**EAST ROSWELL LIBRARY**  
**ADDENDUM NO. 06.1-1**  
**September 19, 2013**  
PAGE 1 OF 1

This Addendum No. 06.1-1 dated September 19, 2013, issued by Ajax Building Corporation of Georgia is hereby made part of Bid Package 06.1 – MILLWORK for the East Roswell Library. The changes and/or clarifications included in this Addendum shall be considered as part of the Bidding Documents and shall supersede, amend, add to, or subtract from those conditions included in the original Bidding Documents, including the Project Bid Package, Drawings, Specifications, previous Addenda, etc. This Addendum must be acknowledged in the space provided on the Proposal Form (included in Section II of the Bid Package). Failure to acknowledge this Addendum may subject Bidder to disqualification.

PROJECT  
**a f m**  
 atlanta-fulton public library system  
**EAST ROSWELL BRANCH**  
 2301 Johnson Bridge Road  
 Roswell, Georgia 30076

**A8.30**

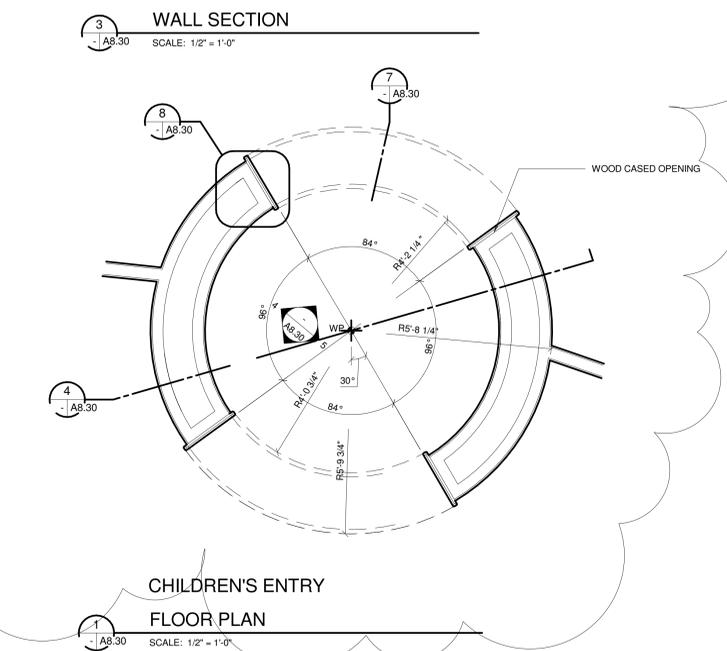
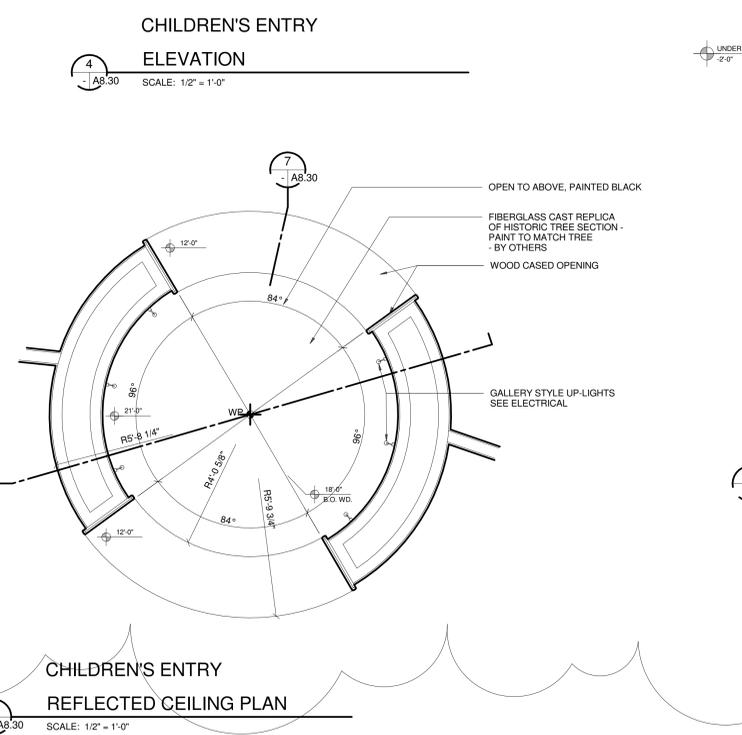
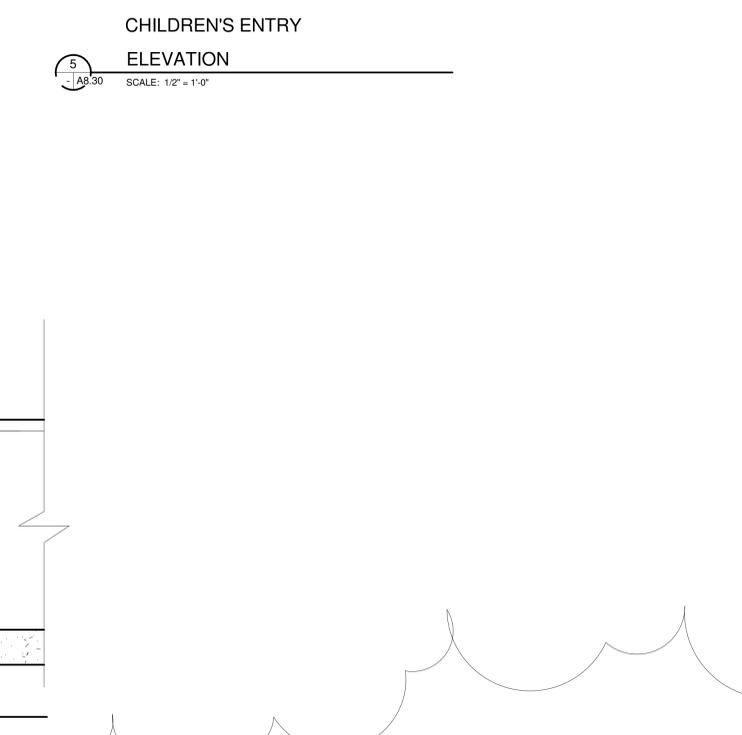
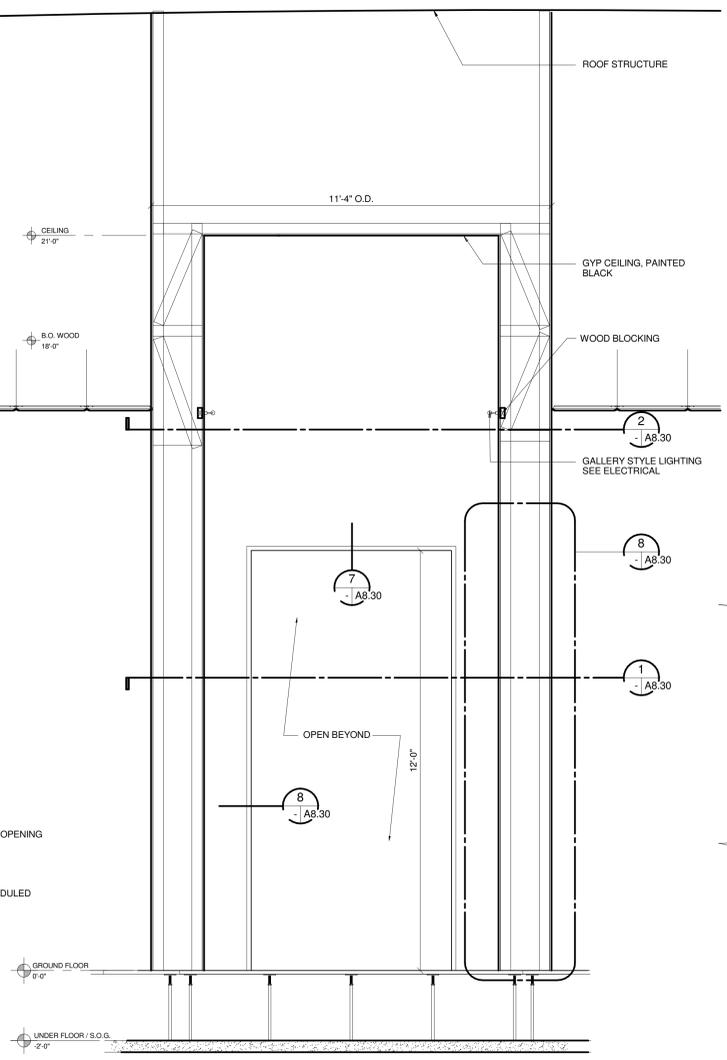
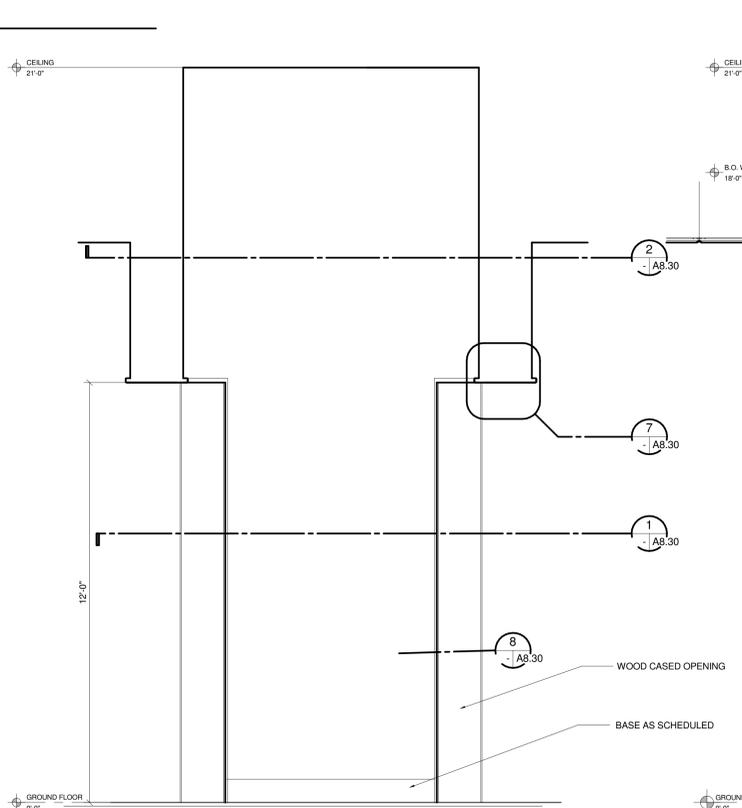
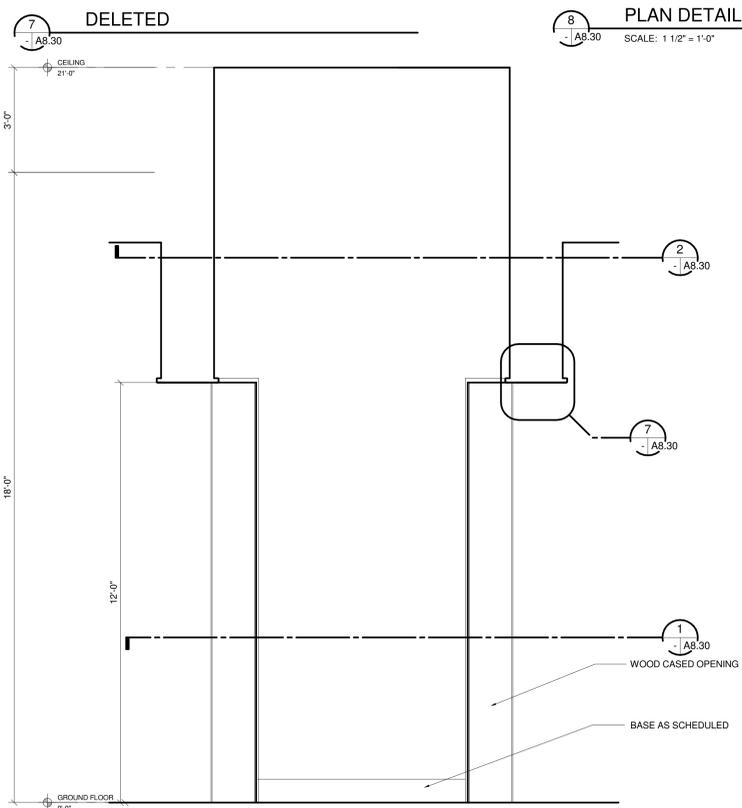
- 1. Per Addendum 6.1-1 dated September 19, 2013, and the VE narrative included in ASI 004 which is shown on page A7.11 include credit for changing Change 27 wood end panels to Laminate - Change 14 Wood with slat panels to flush laminate without Slat Panels, and removal of three display cases.**
- 2. Per Addendum 6.1-1 dated September 19, 2013, and the VE narrative included in ASI 004 which is shown on page A8.30 provide credit for the changes to the entry way of the Children's area.**

Provide credit for the changes to the entry way of the Children's area.
